Islamic Emirate of Afghanistan  
Administrative Office  
National Procurement Directorate  
Technical Deputy

اسم پروژه: تهیه و تدارک، دیزاین، نصب و تست و کمیشننگ، ترانسفرمر بی ظرفیت 40MVA , 110/20KV و تدارک تجهیزات برقی و مواد ساختمانی نصب و متناژ تست و کمیشننگ تمدید لین دبل سرکت ۲۰ KV سولر استیشن MW ۲۲,۷۵ سربوی

تعدیل شماره 2 و توضیحات

نمبر تشخیصیه: NPD/DABS/1403/NCB/W-1135

# CONCEPT SLD 20/110kV TR BAY FOR SOLAR PLANT

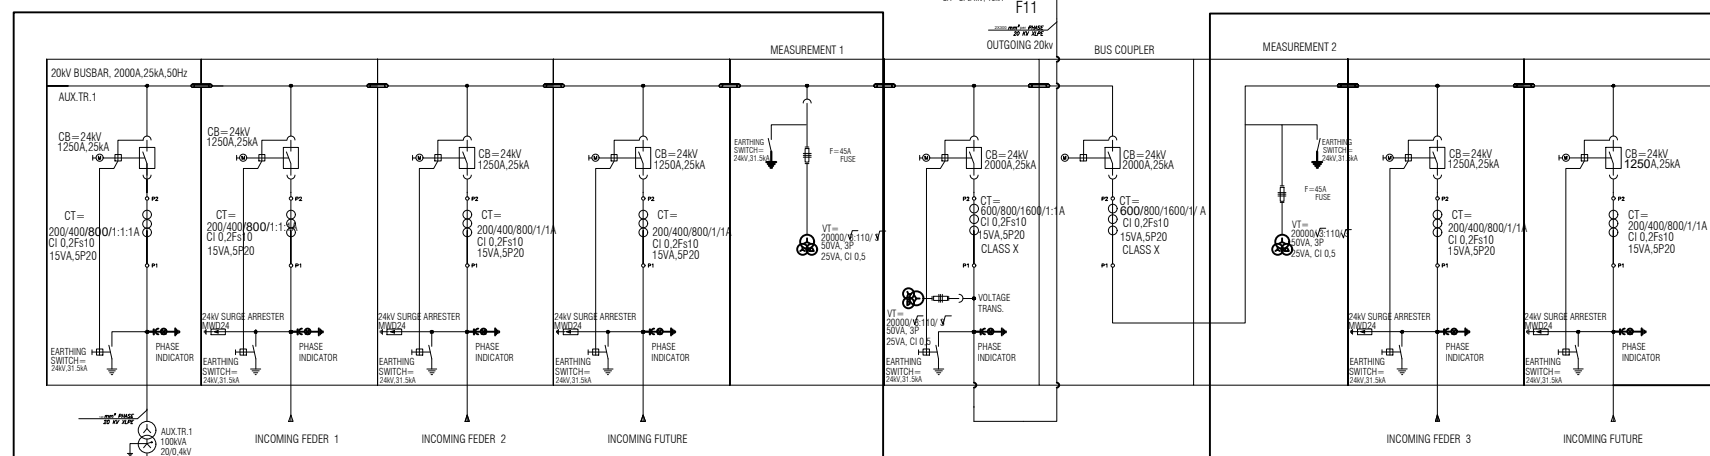
7.	Could you kindly a readable PDF Copy or an Auto CAD file of the attached Concept design. Which is included in the Technical specification on pages on pages 138-141 of the for subjected Bid	Readable Concept SLD is attached Bellow.

10.	Could you kindly provide a readable PDF copy or an AutoCAD file of the attached concept design, which is included in the Technical Specifications on pages 138-141 of the 241-for subjected bid?	Technical Specifications on pages 138- 141 of the 241 (for more information the Concept SLD is attached).
